N9917A-02

S E R V I C E N O T E

N9917A FieldFox Handheld Analyzer

Figure 1: Image showing the good and bad inductor on location U678 at RF Board

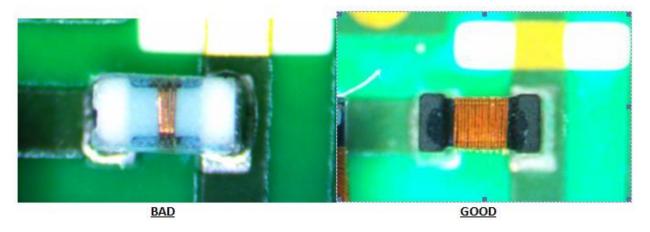
FieldFox instruments with the serial numbers listed below may show potential DANL failures with 3-4 dB difference due to misloaded inductor on the RF board. If DANL improvement is necessary, a new RF board is available to fix this it.

Affected FieldFox with necessary DANL improvement are required to send back to Agilent factory for a new RF board replacement. Test and Adjustment shall be done before shipping back to customer.
